# Access Compliance Report

## Public Rights-of-Way

### (Curb Ramps)

Intersection ID: 10020680	Main Street: BEAM_RD	Cross Street: N/A	Location: E
ADA ID: 8C22A80F5ED5	Ramp Type: Perp	Initial Pass/Fail: Fail	Overall Compliance: No
Codes/Mitigation Info/Possible Solution		Field Measurements/Component Compliance	
Severity Score: 13.75

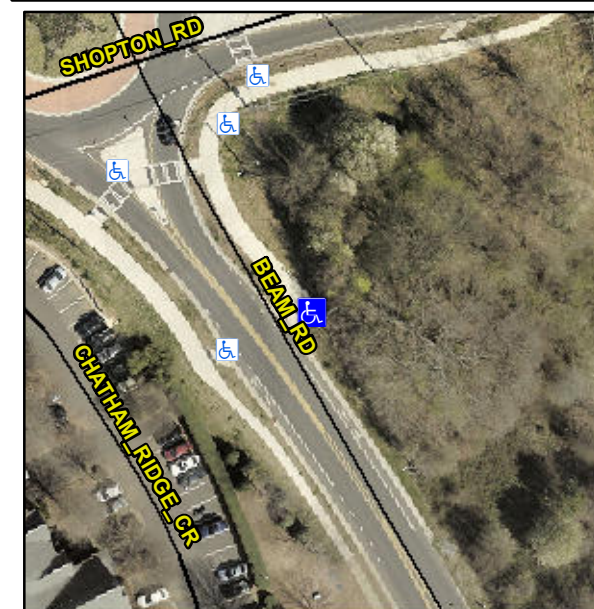
**R304.2.2, R304.5.3**

Compliance	Description	Data	Compliance	Description	Data
N/A	Ramp Length (in)	98.0	No	Ramp Slope (%)	8.9
Yes	Ramp Width (in)	95.0	No	Ramp XSlope (%)	4.9
N/A	Flare Type LT	N/A	N/A	Flare Type RT	N/A
N/A	Flare Slope LT (%)	N/A	N/A	Flare Slope RT (%)	N/A
N/A	Flare Traversable LT?	N/A	N/A	Flare Traversable RT?	N/A
N/A	Landing Length (in)	N/A	N/A	DWS Provided?	N/A
N/A	Landing Width (in)	N/A	N/A	DWS Contrast?	N/A
N/A	Landing Slope (%)	N/A	N/A	DWS Length (in)	N/A
N/A	Landing X Slope (%)	N/A	N/A	DWS Full Width?	N/A
N/A	Landing Curb? (Y/N)	N/A	N/A	DWS Offset (in)	N/A
N/A	Shared Landing?	N/A			
N/A	Gutter Ponding?	N/A	N/A	Gutter Slope (%)	N/A
N/A	Gutter Lip Ht (in)	N/A	N/A	Gutter X Slope (%)	N/A
N/A	Painted X Walk1?	No	N/A	Painted X Walk2?	N/A
	X Walk 1 Direction	To W		X Walk 2 Direction	N/A
N/A	X Walk 1 Width (in)	N/A	N/A	X Walk 2 Width (in)	N/A
	X Walk 1 Slope (%)	2.3		X Walk 2 Slope (%)	N/A
	X Walk 1 X Slope (%)	3.6		X Walk 2 X Slope (%)	N/A

**Remove & Replace Entire Ramp.**
